### South Midland Bid Questions – Received via Email after Addendum #3:

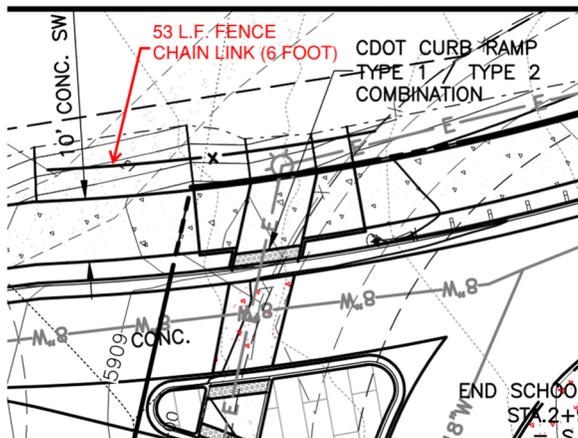
- 7) Q: Note 2 on sheet number 96 requires the concrete slope and ditch paving to have wire mesh. Also, note 2 refers to CDOT section 507 which requires the concrete to be Macro Fiber-Reinforced Class B concrete. Are both Wire mesh and Fiber reinforcement required for the apron?

*A: Either type of reinforcement is acceptable. Please note that if fiber reinforced concrete is used it will require its own approved concrete mix design.*
